Geotechnical Exploration, Inc.

Job No. 01-8018

Subject: **Response to DSD-Geology Comments**
Proposed Lowenthal Residential Project
1720 Torrey Pines Road
La Jolla, California

PLOT PLAN AND SITE SPECIFIC GEOLOGIC MAP

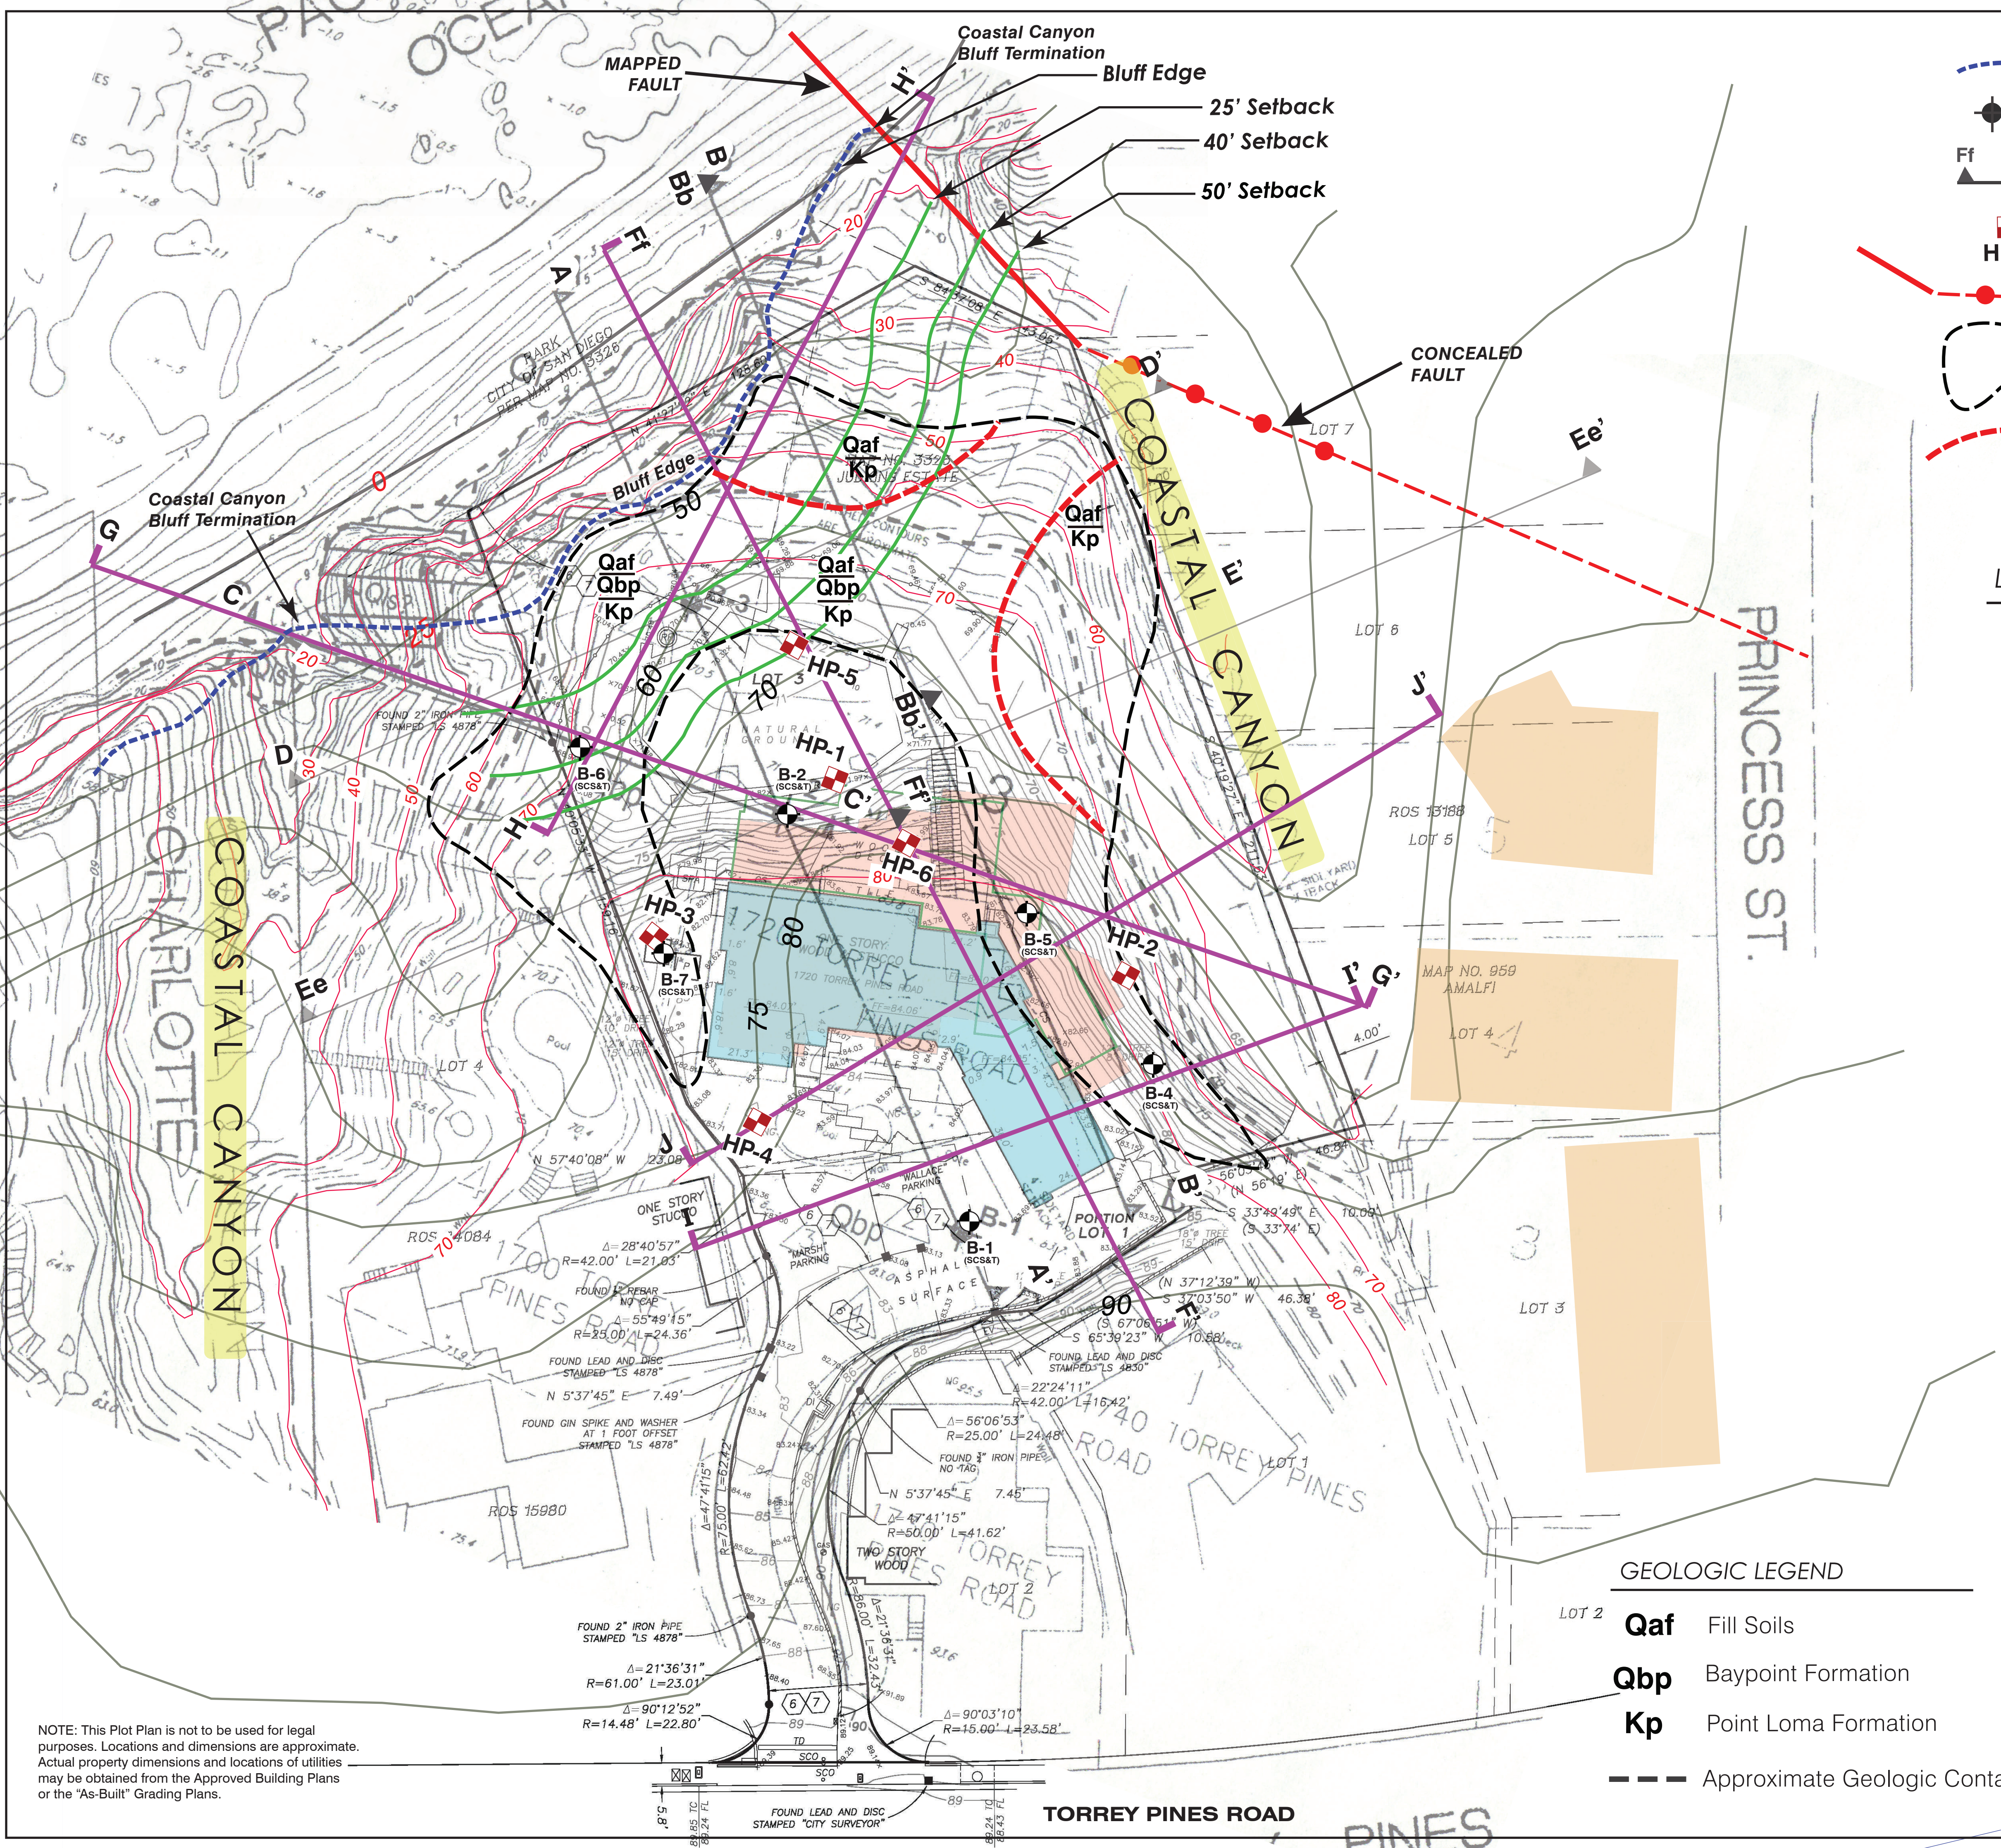
DSD-Geology Comment 00118 |Page| Open: Please provide the updated geotechnical map with artificial fill shown, the additional cross sections, and additional slope stability analysis from the discretionary review PRJ-1111223

GEI Response to Comment 00118: In this response as Appendix A, we are providing the new cross section J-J', the updated geotechnical map showing the artificial fill, the location of the new cross section J-J', and the location of updated cross sections Bb-Bb', E-E', F-F', G-G'. We are also providing the updated slope stability analysis for all cross sections provided.

*Slope Stability Analysis for Cross Sections
J-J' dated March 20, 2025*

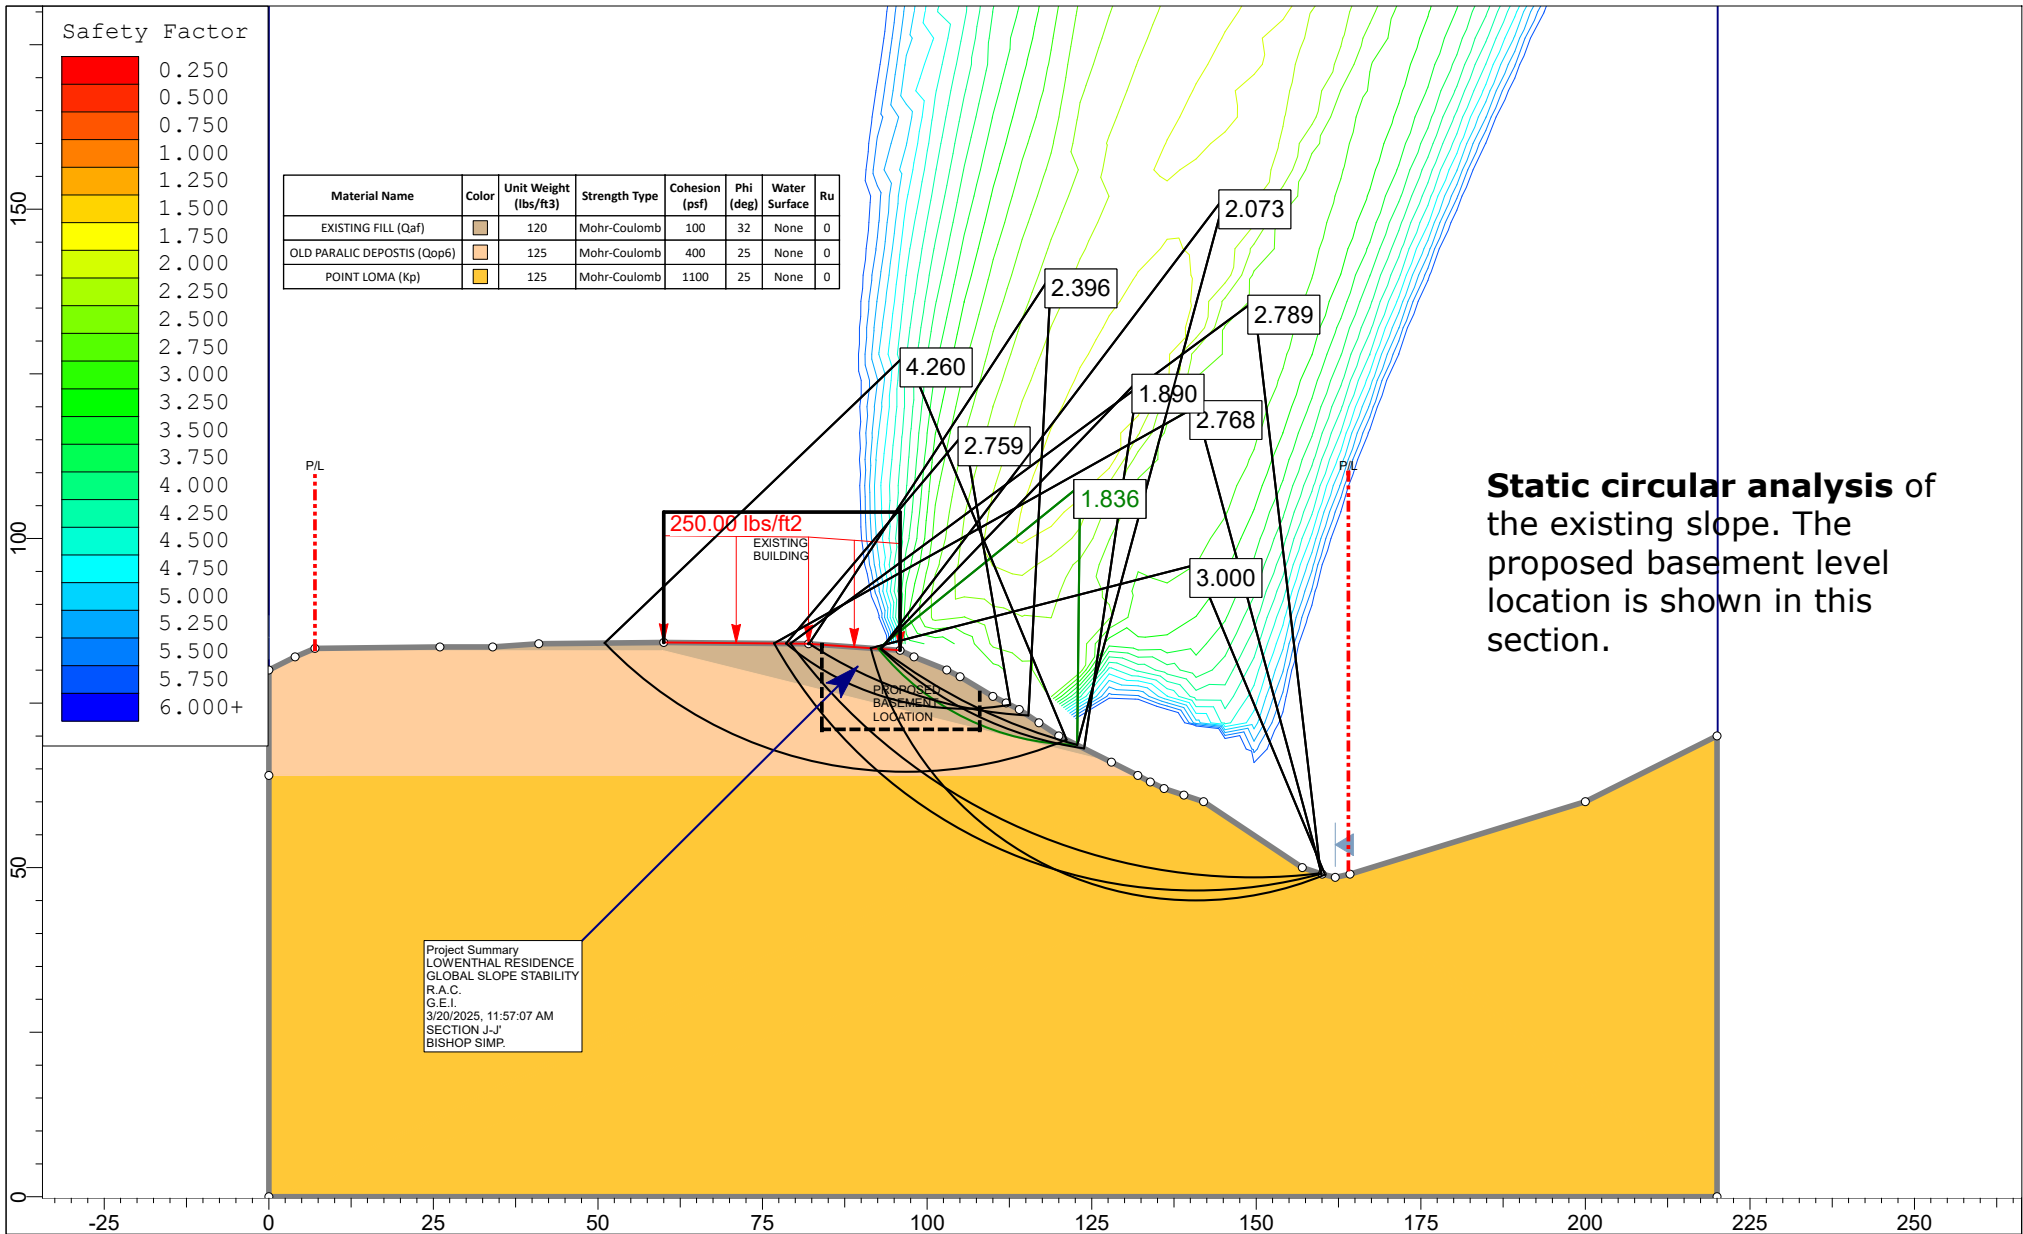
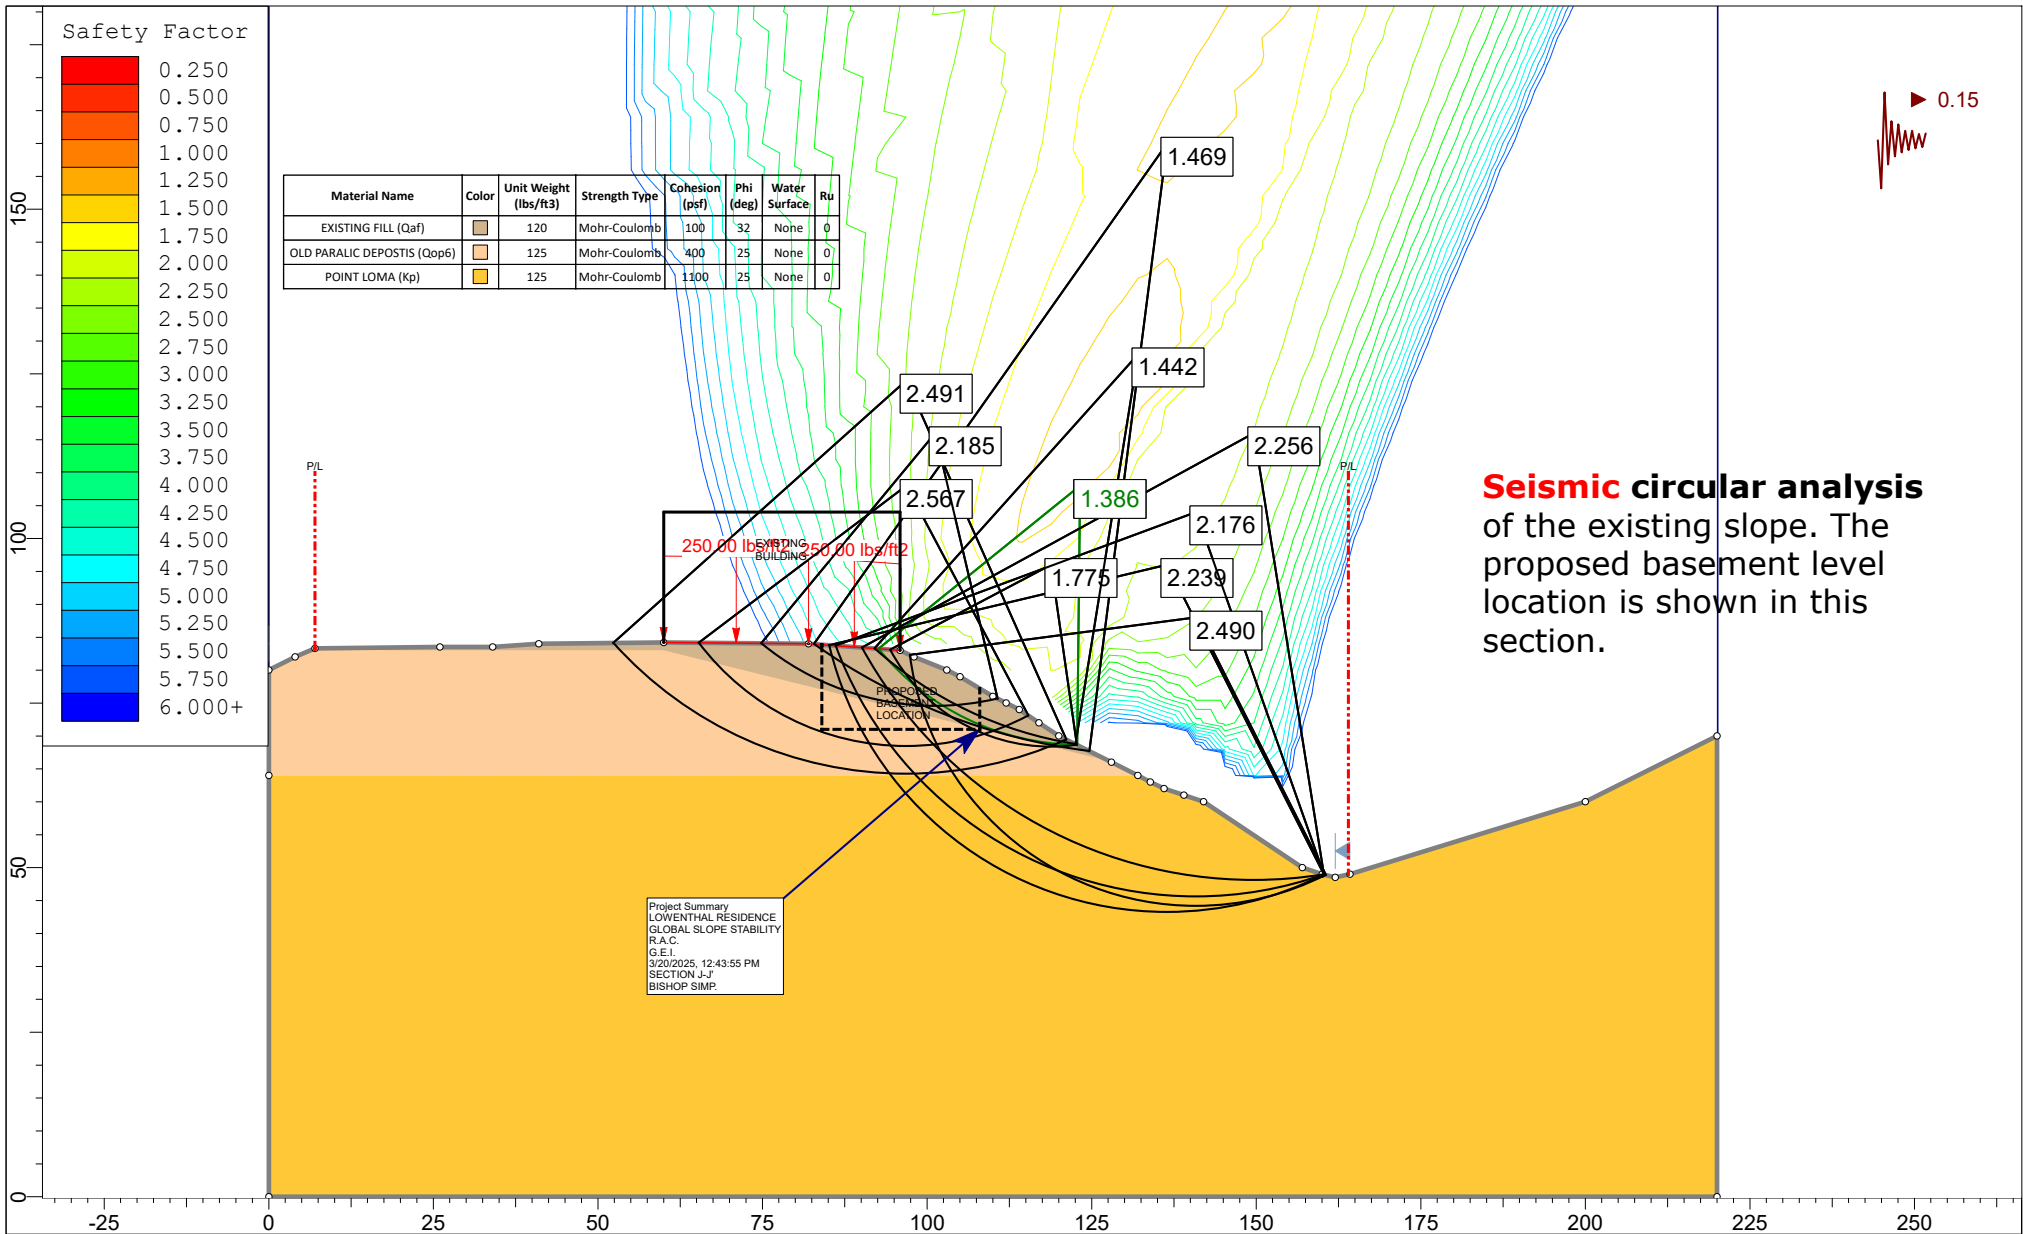
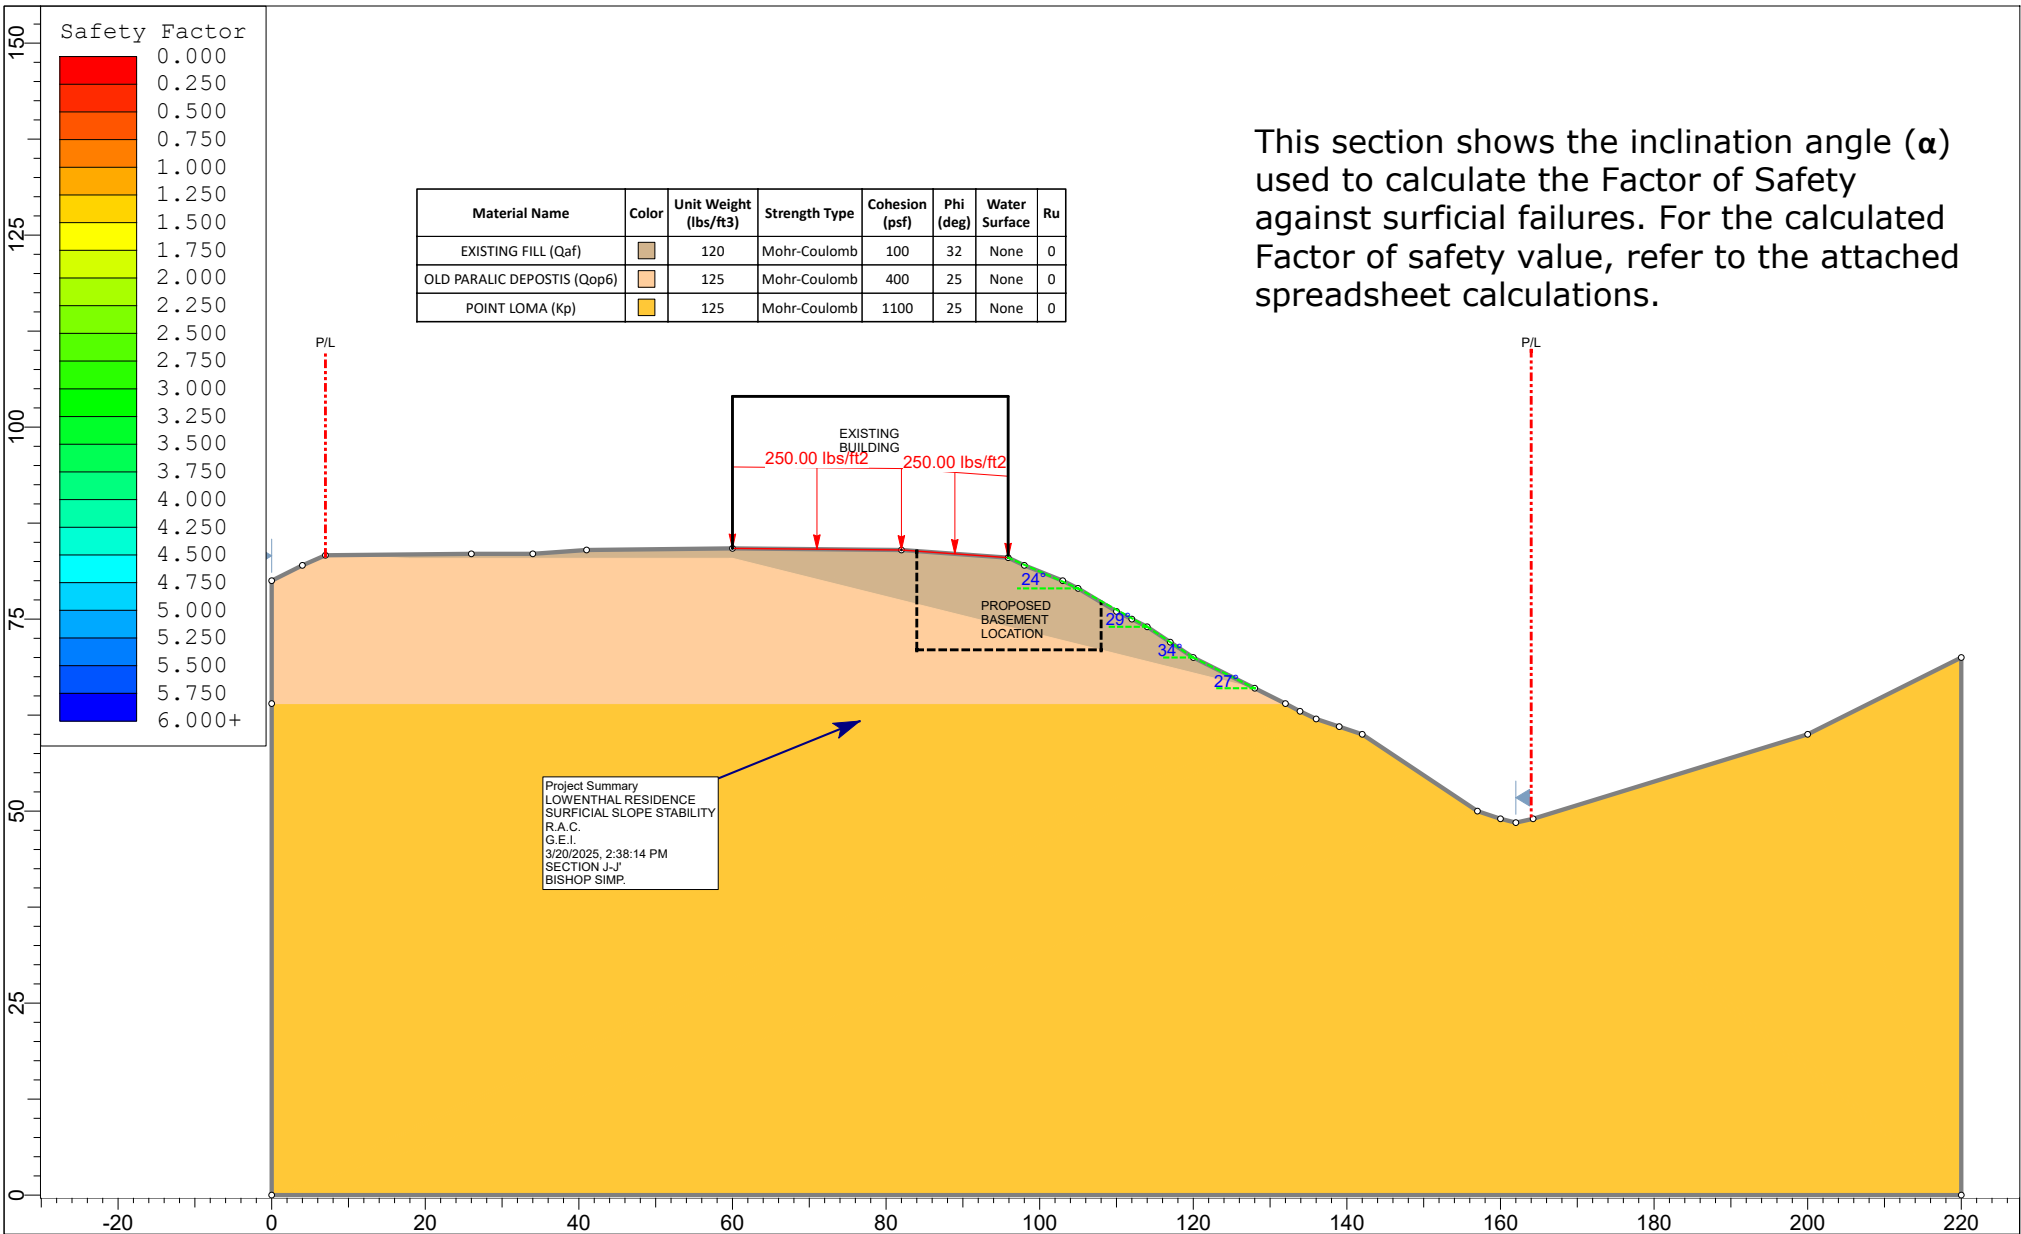
DSD-Geology Comment 00116 |Page| Open: *The project's geotechnical consultant has provided the analysis for the proposed slope on page 20 of the submitted report and now must provide a professional opinion that the site will have a factor of safety of 1.5 or greater for both gross and surficial stability following project completion*

GEI Response to Comment 00116: It is our professional opinion that following project completion in accordance with our recommendations, all site slopes will have a factor of safety of 1.5 or greater for both gross and surficial stability and greater than the acceptable value of 1.15 under seismic loading conditions.
